## **Med Tips**

October 2013

## **C1000 Case Screw Changes**

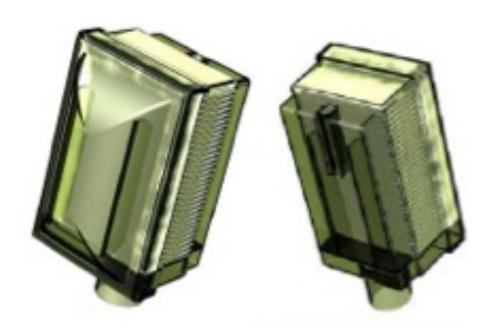
CAIRE has updated the screws used on the C1000 liquid oxygen portables. A number of the screws used on the C1000 case are similar in size. Therefore, CAIRE has consolidated the the various types of screws necessary for the case. Only two types of screws will now be used for the C1000 case. This allows for easier and simpler service. Please see the photos below for details regarding the newly updated part numbers.
